Subject: Carlyle Greger, Carlyle Machine - To seek site plan approval for a new 10,950 sq. ft. building to manufacture prototypes in the medical industry located at 1671 East 145 South, consisting of approximately 1.00 acres. Application 25-023A

Planning Commission Staff Evaluation – Second Review

APPLICATION: 25-023A

STAFF COMMENTS – SECOND REVIEW

SHEET NUMBER
1.2

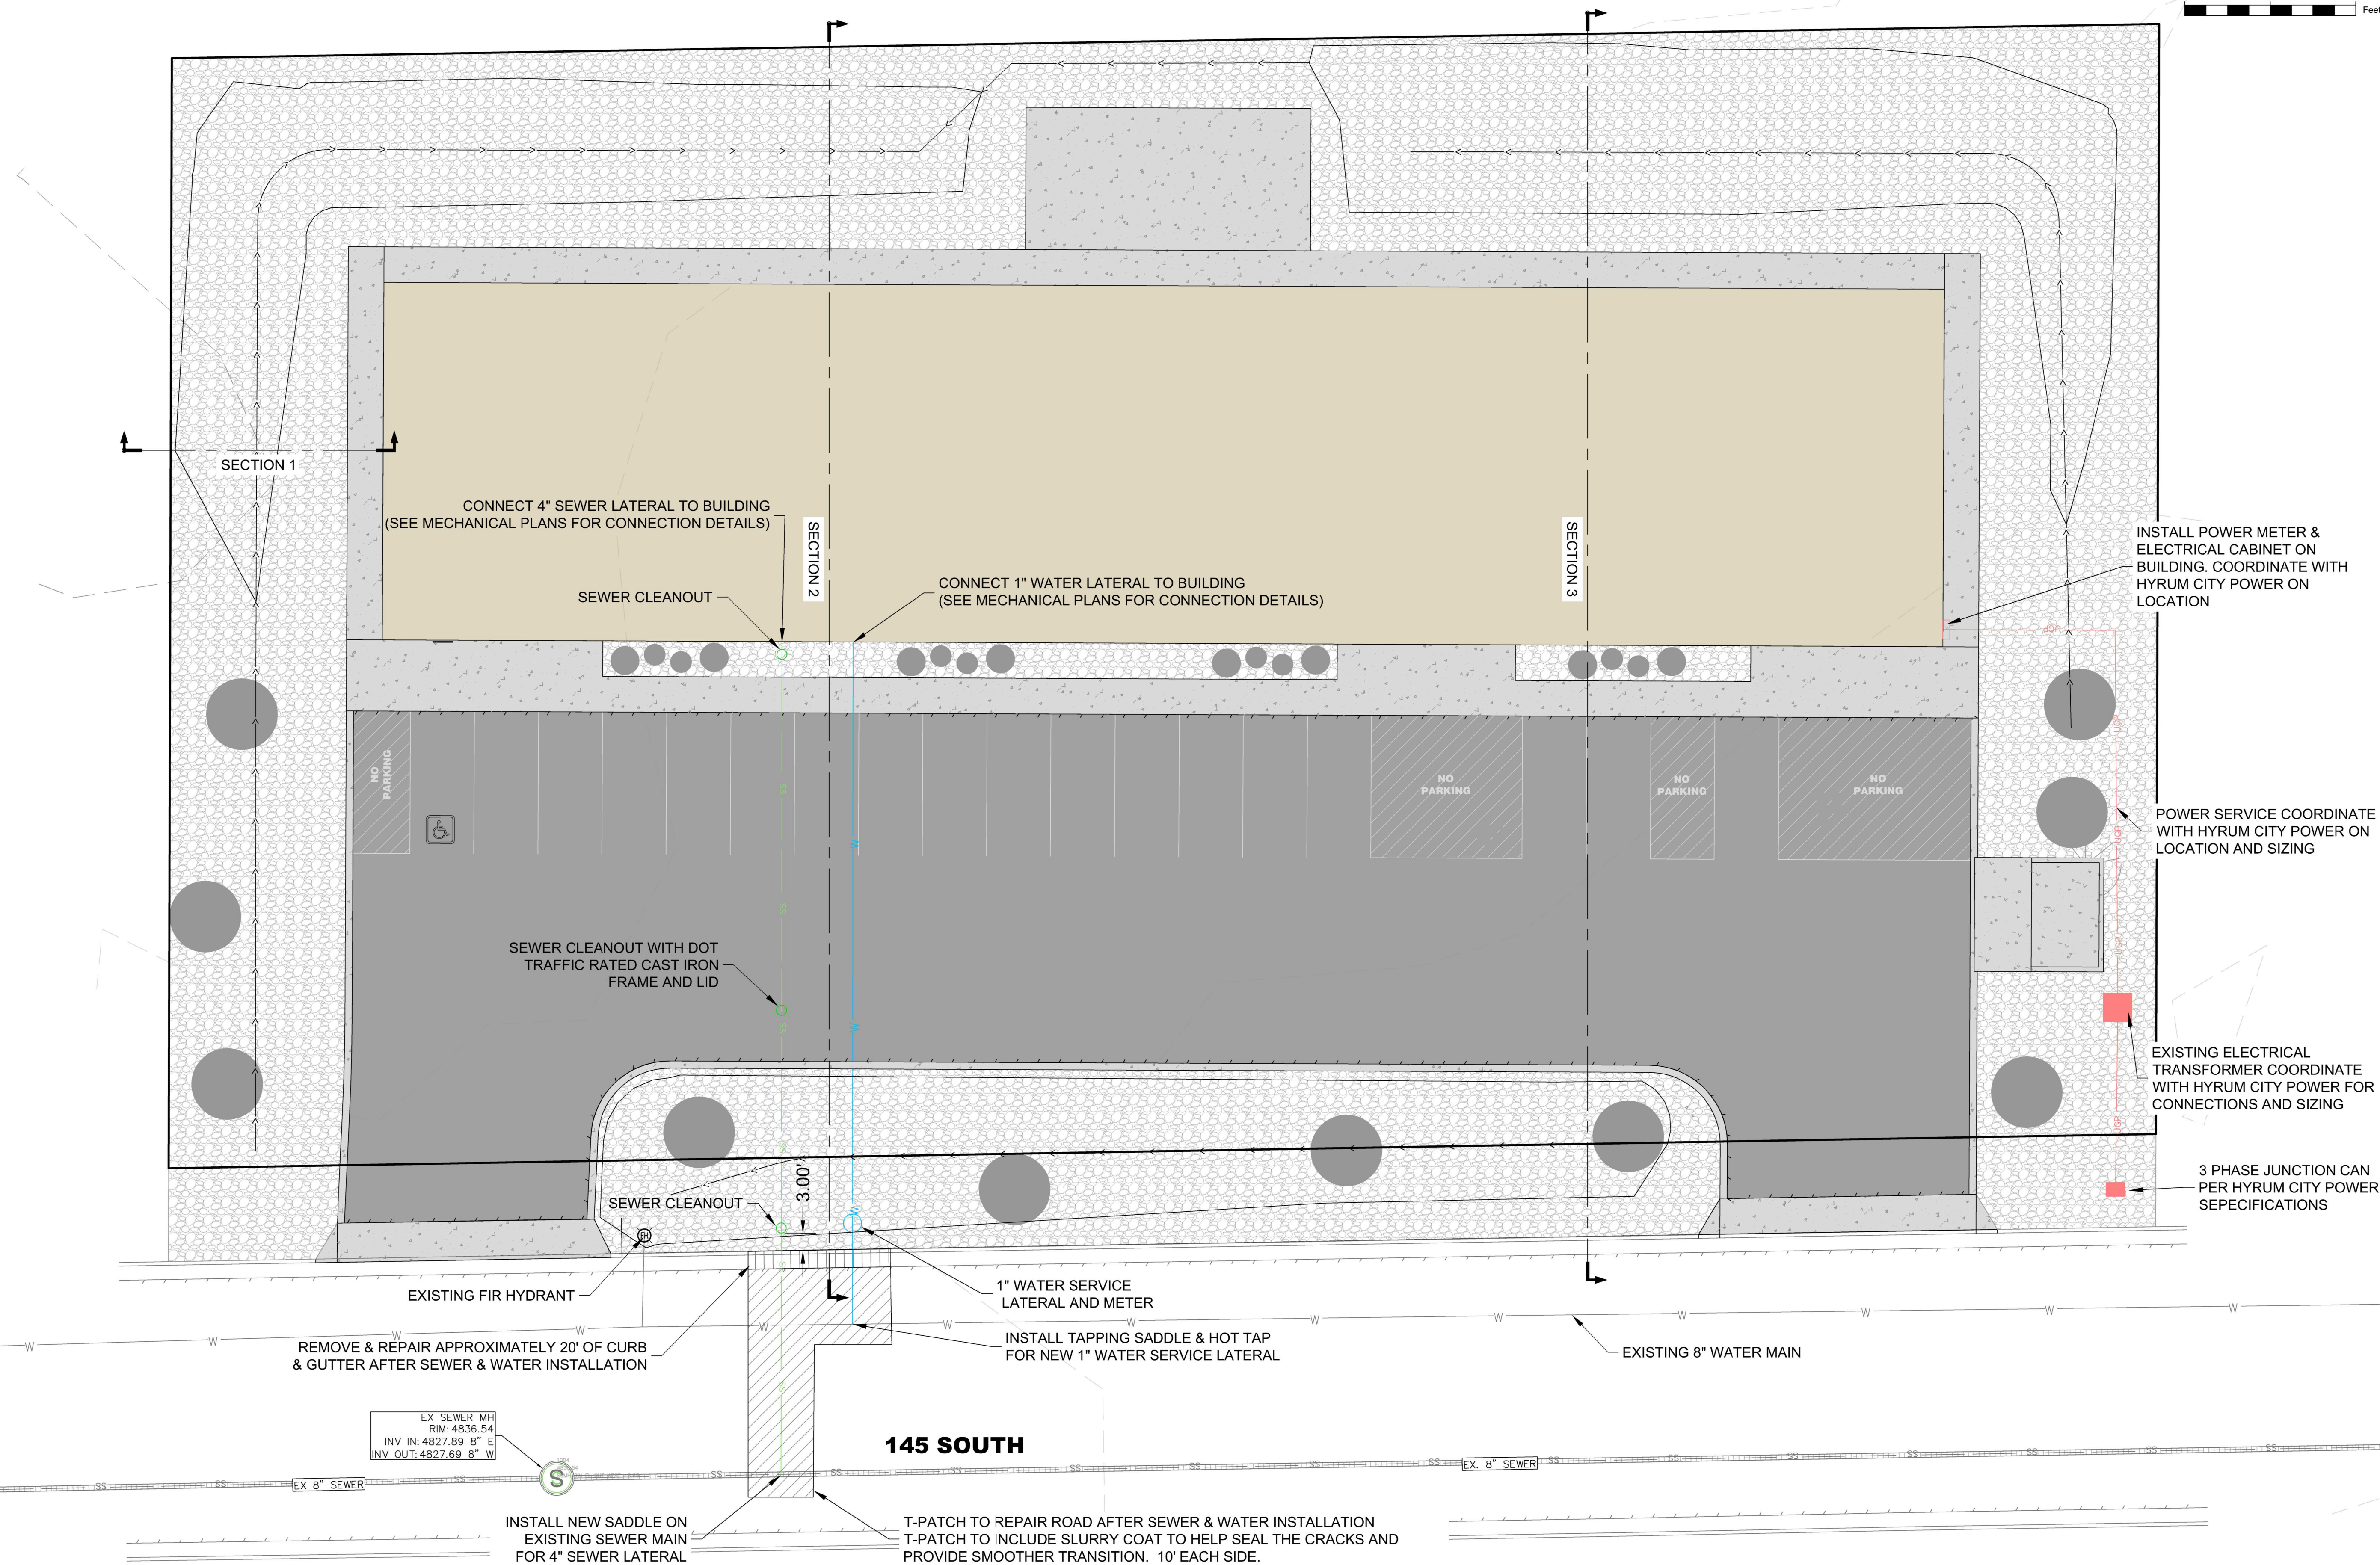
1. Please verify that the lateral and meter pit is not already stubbed into site before excavation of the road (most parcels in this area were pre-installed). For installation, please follow Hyrum city standards and remember sewer and water must maintain 10 feet of horizontal separation.

2. The water meter pit shall provide and maintain three feet (3') clearance from the back of the concrete curb, bank of detention pond, and landscape planting materials such as shrubs and trees.

1. A lateral cleanout is located outside of structure per standard; however, cleanouts need to be installed at 50' intervals on 4" laterals which is not shown on the drawing. Refer to Construction Standard, 5.2.2.F.

2. If a cleanout must be placed in asphalted streets, a cast iron frame and cover should be used. Refer to drawing 5-36.

Our surveyor was not able to locate any stubs, but a note was added for the contractor to field verify any existing utility stubs prior to installing new ones. There is also a note added to the utility plans that the contractor shall follow all Hyrum City standards and specs along with the note to maintain 10' separation between water and sewer.

The water meter and sewer cleanout is now moved back the requested 3' behind the TBC

There are 2 new cleanouts added to the utility plan at the required minimum 50' separation.

One of the cleanouts is located in the parking drive area and a note was added to use a DOT rated cast iron frame and lid.

A3 SITE LIGHTING PLAN
SCALE: 1/16" = 1'-0"

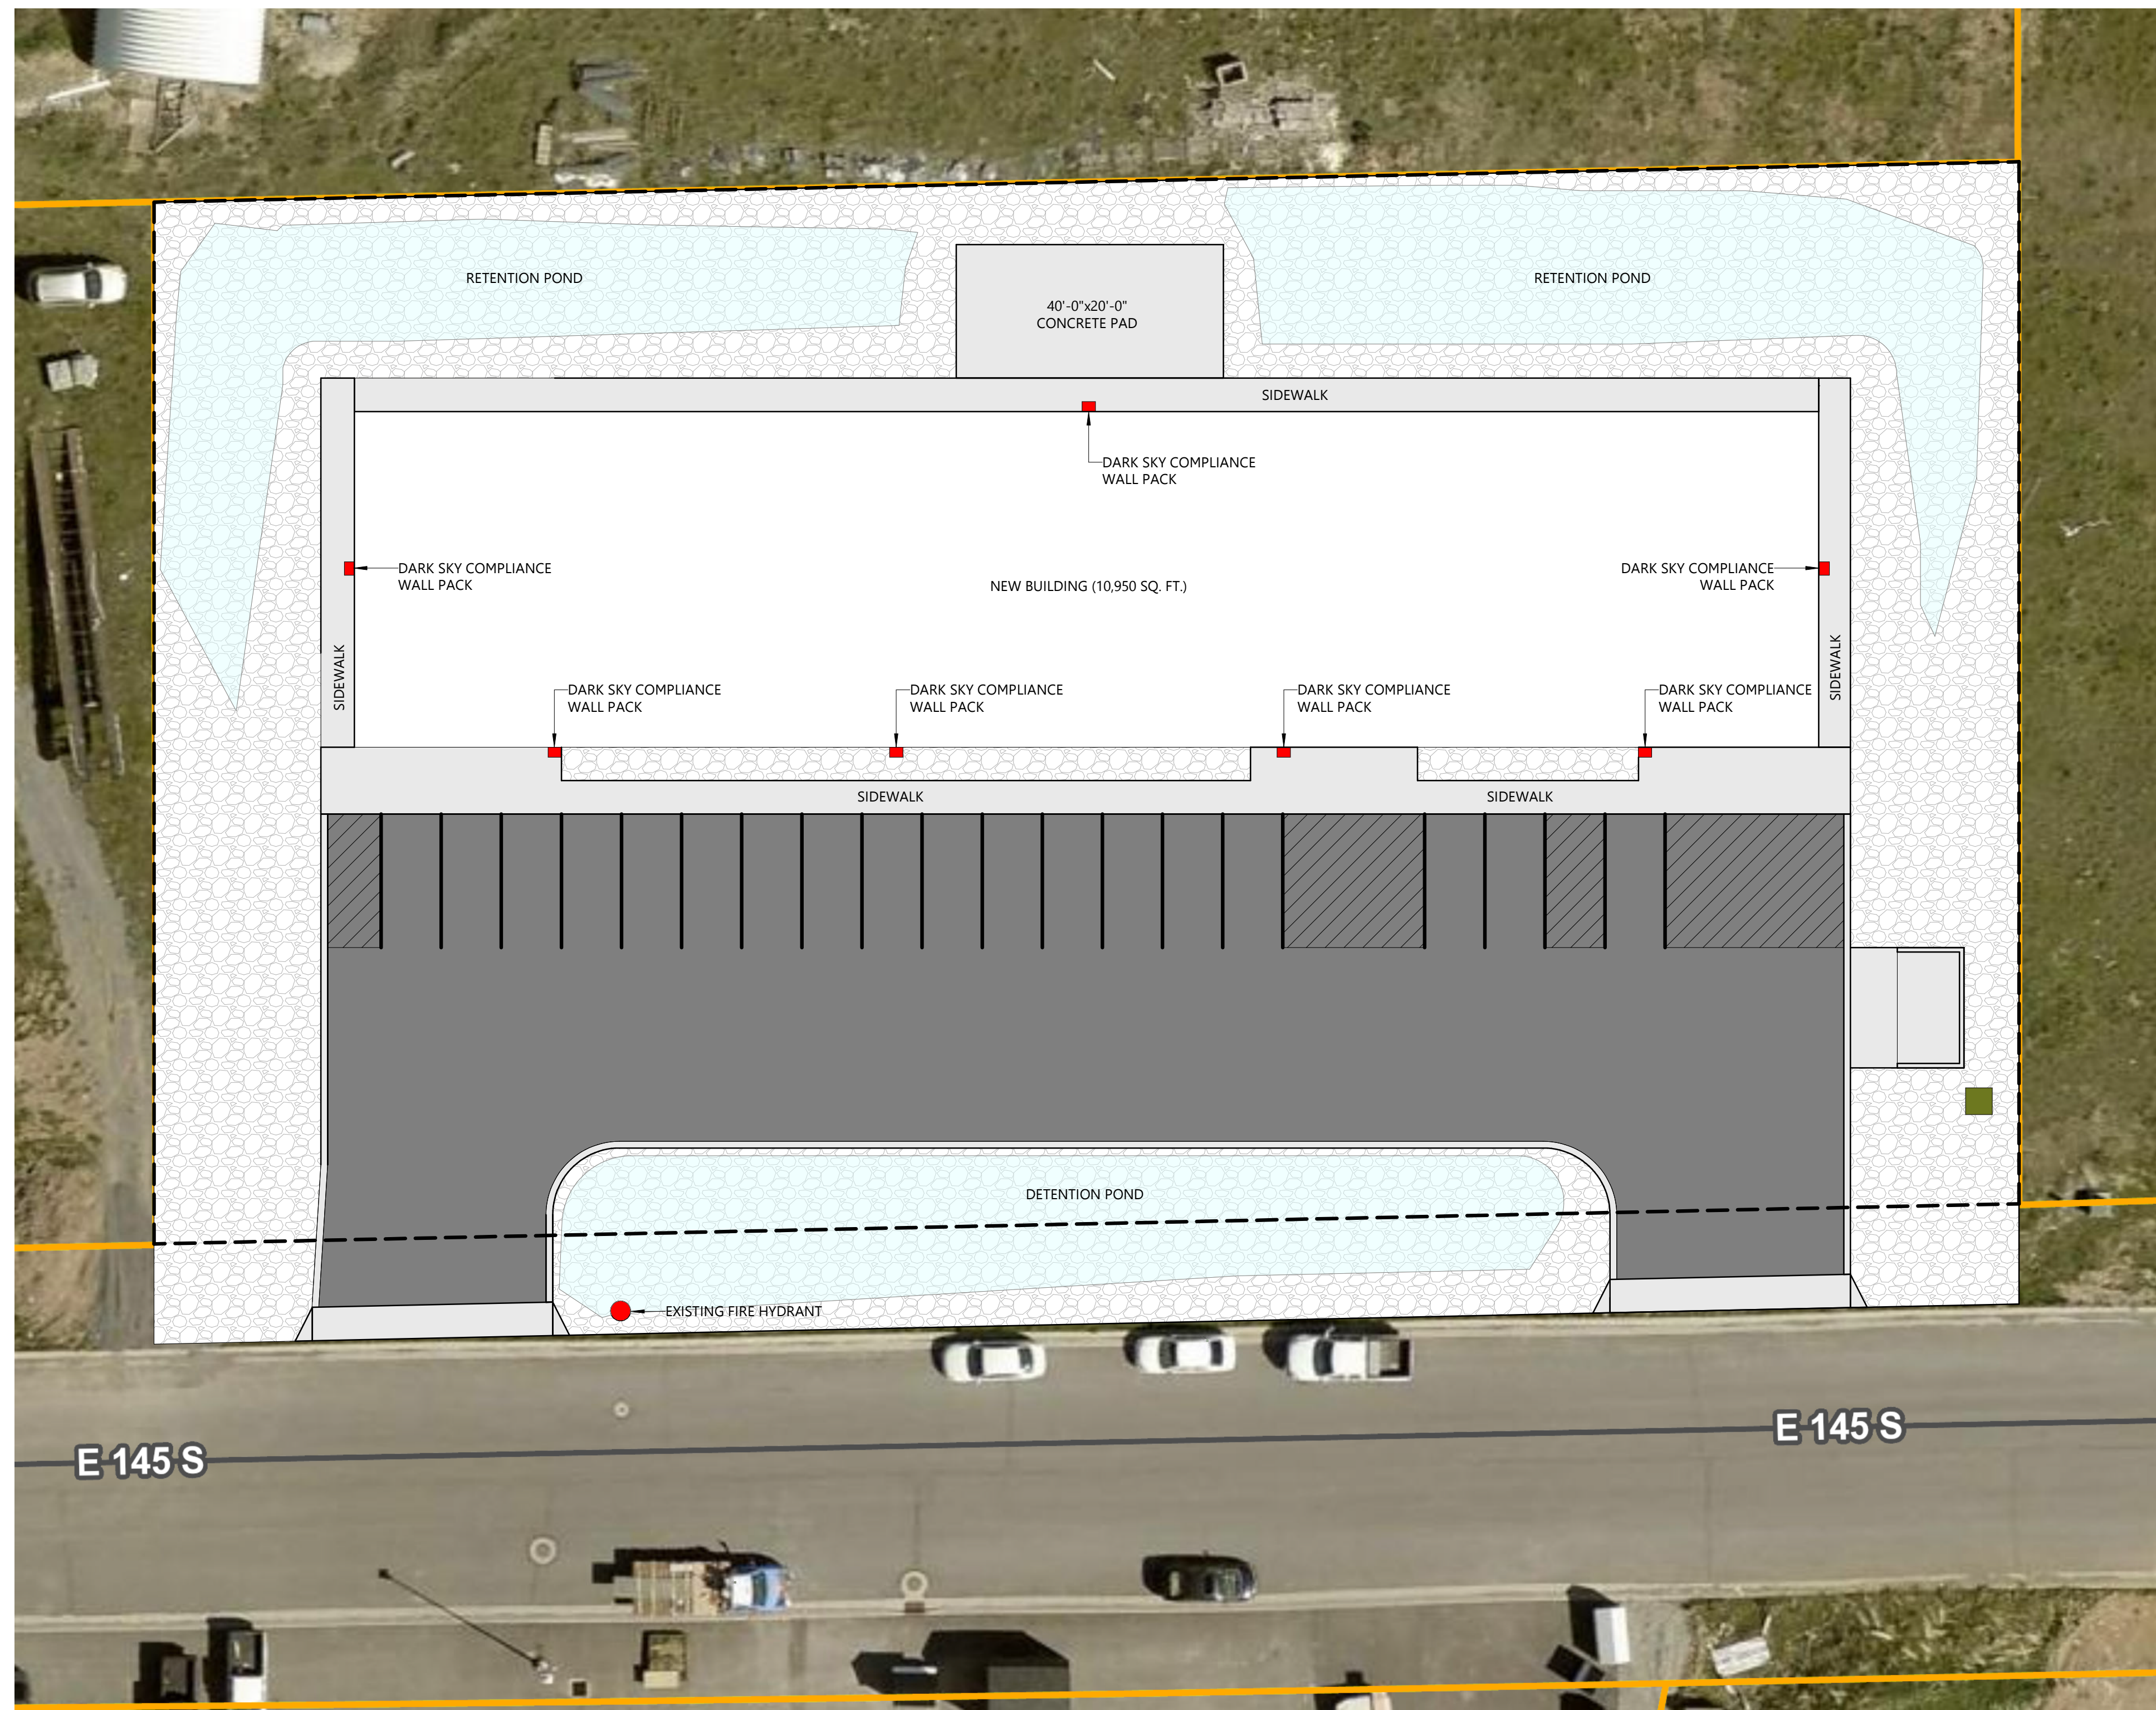
1. Each site plan shall include a lighting plan that is designed to discourage crime, enhance the safety of the project, and the parking lot and structure shall be well lit while preventing glare onto adjacent properties with dark-sky initiatives. Please submit the required lighting plan for Site Plan Approval. See HCC 17.49.022. ?
